**Comanche Peak Nuclear Power Plant, Units 3 & 4
COL Application**

FSAR Revision1

Update Tracking Report

Revision 4

Figure 8.3.1-1R Onsite AC Electrical Distribution System (Sheet 5 of 7)
Class 1E 480V Buses A and B One Line Diagram

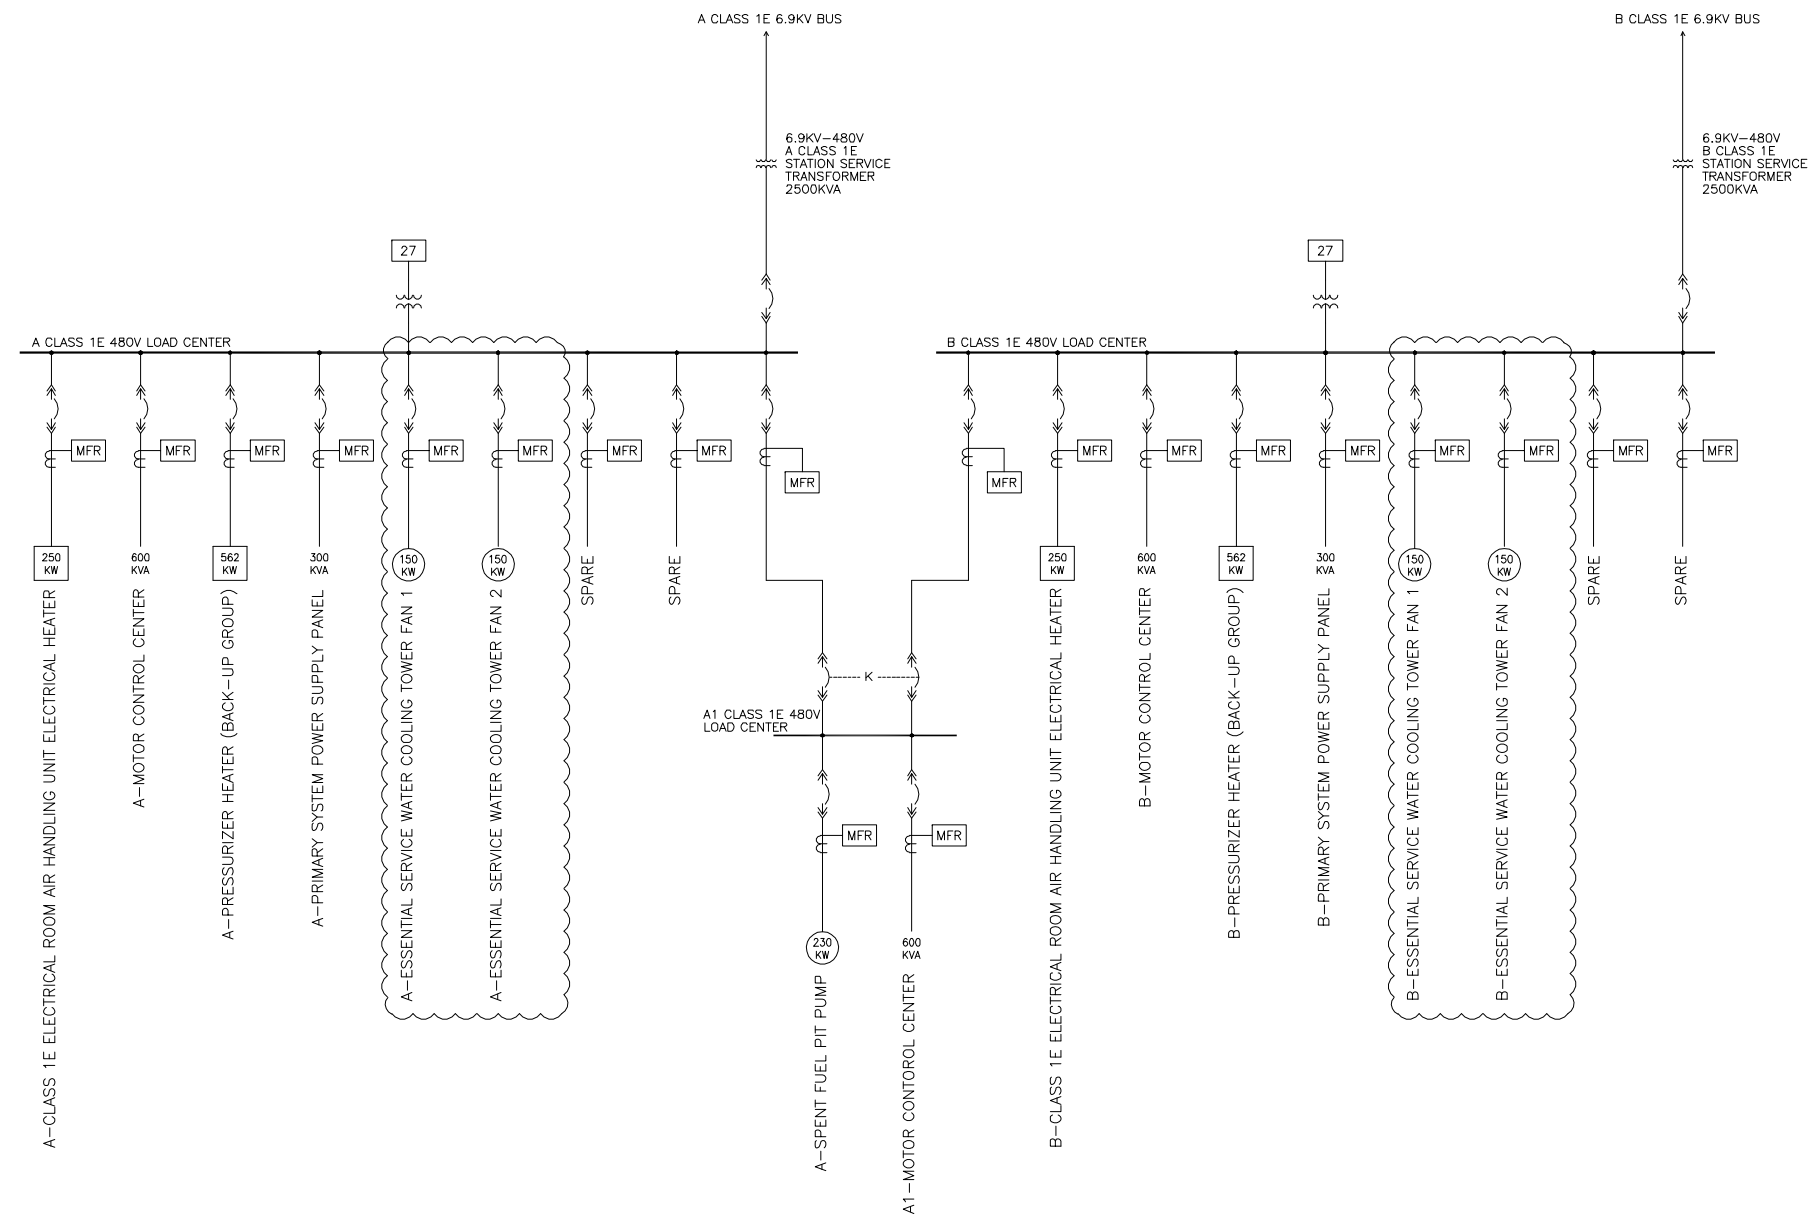
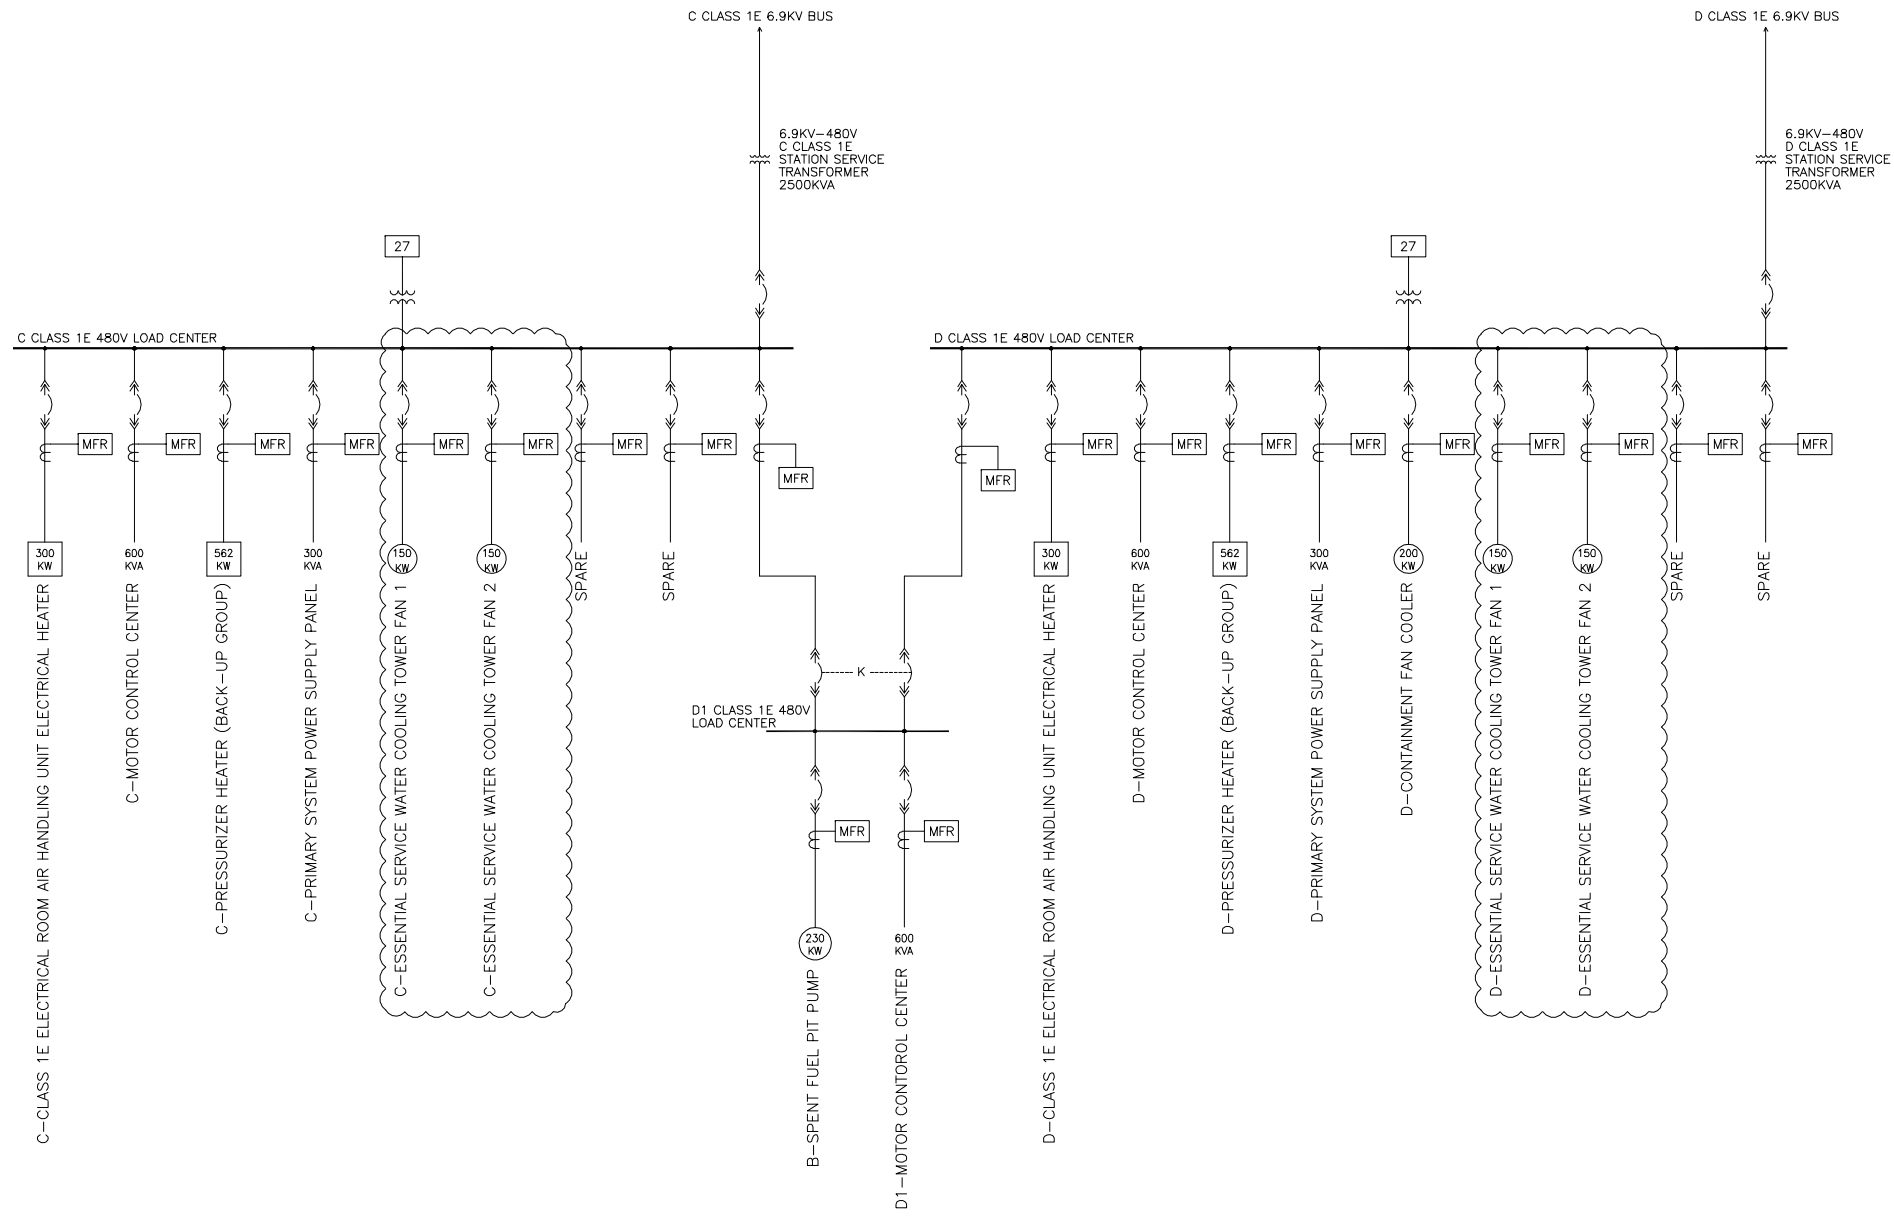
| Change ID No. | Section | FSAR Rev. 1 Page* | Reason for change | Change Summary | Rev. of FSAR T/R |
|----------------|---|---|--|--|------------------|
| CTS-01140 | 8.2.1.2 8.2.3 8.2.4 Table 8.3.1-4R Figure 8.3.1-1R Sheet 5 and 6 of 7) Figure 8.3.1-2R Sheet 18 through 21 of 24) | 8.2-3 8.2-12 8.2-13 8.2-14 8.3-6 Through 8.3-9 8.3-11 8.3-12 8.3-17 Through 8.3-20 | Standardization | Changed LMN to STD and where needed, removed or replaced reference to CPNPP Units 3 and 4 | 4 |

Figure 9.4-201 UHS ESW Pump House Ventilation System Flow Diagram

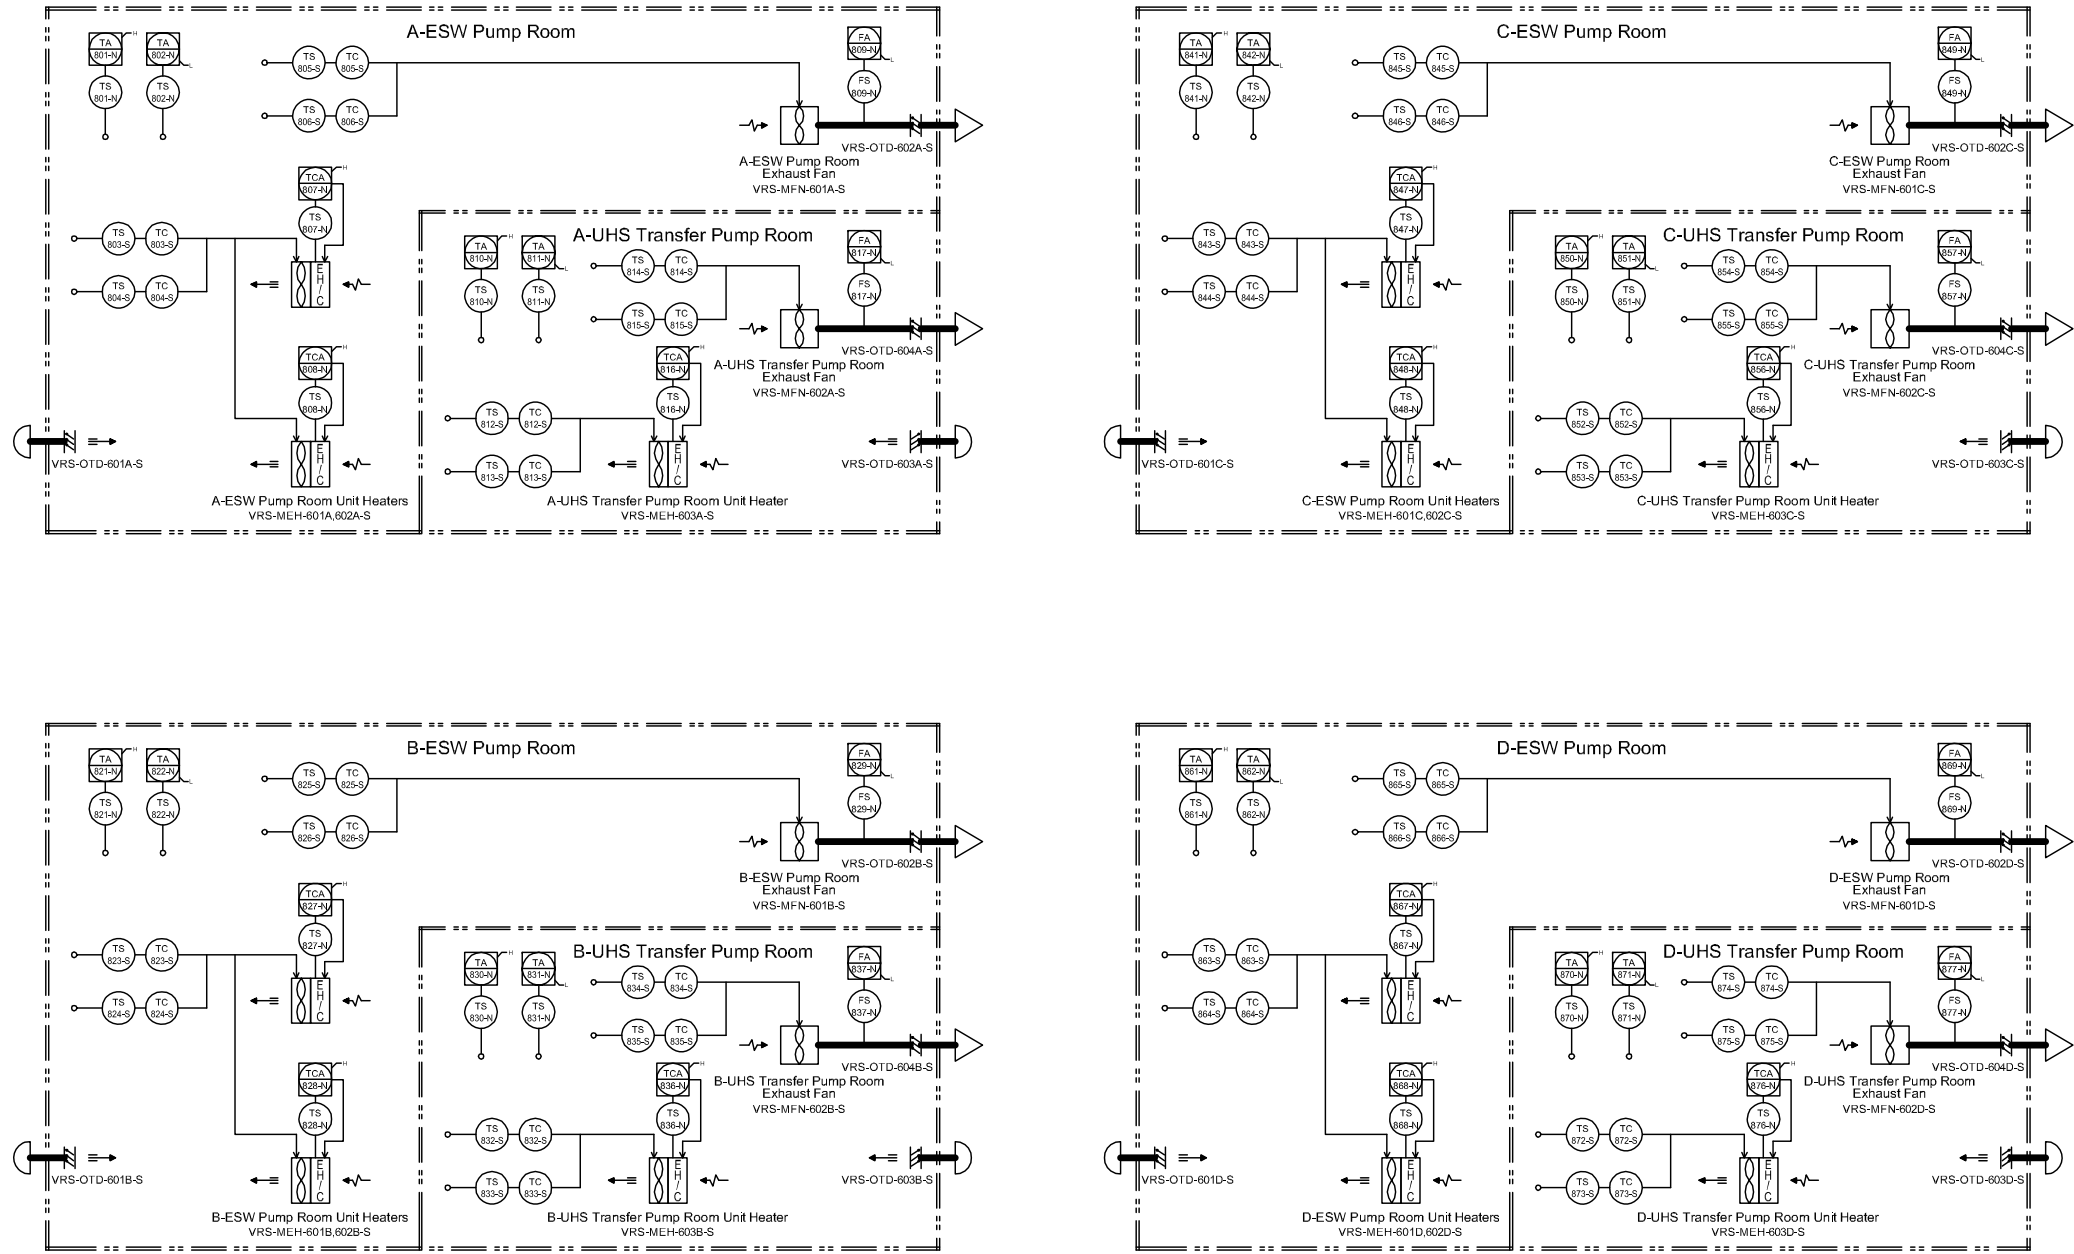
| Change ID No. | Section | FSAR Rev. 1 Page* | Reason for change | Change Summary | Rev. of FSAR T/R |
|-------------------|-------------------|-------------------------|---|--|---------------------------|
| RCOL2_09.04.05-03 | Figure 9.4-201 | 9.4-17 | Responses to RAI No. 123 Luminant Letter no. TXNB-09081 Dated 12/16/2009 | Added four notes to Figure 9.4-201. | - |

| Change ID No. | Section | FSAR Rev. 1 Page* | Reason for change | Change Summary | Rev. of FSAR T/R |
|-------------------|---|--|--|---|------------------|
| MAP-00-201 | Table 9.2.5-202 Figure 9.2.1-1R Figure 9.2.5-201 Figure 9.4-201 | 9.2-19 through 9.2-22 9.2-24 9.2-25 9.4-10 | The change of numbering rule of Tag number | Change Tag numbers. | 0 |
